Technical Service Bulletin – 032

DBCOIL IL – Damper Shaft Update

Rev01 – 7/2/19 – Sam A

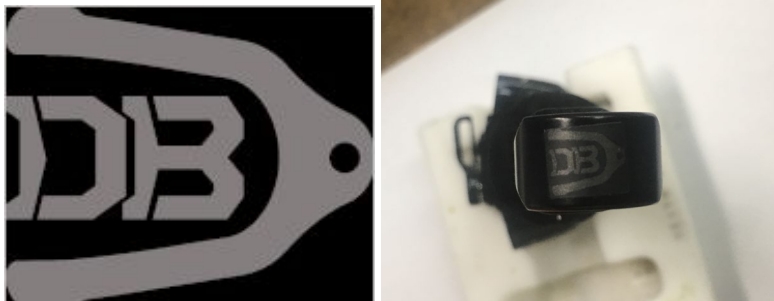
On June 17th 2019 Cane Creek started 100% production of DBCOIL IL rear shocks with a solid damper shaft. This provides additional strength for fitment on clevis mount bikes and other bikes that inflict side loading onto a rear shock. Due to the same exterior shape and finish on the solid shafts compared to the hollow shafts, Cane Creek is now applying this sticker to the end eye of each COIL IL as well as on the box of a new COIL IL to differentiate the new solid shafts inside the shock:

These stickers will be sent with all of the new solid shaft assemblies and are to be applied to the end eye of the shock during a solid shaft installation at the service center.
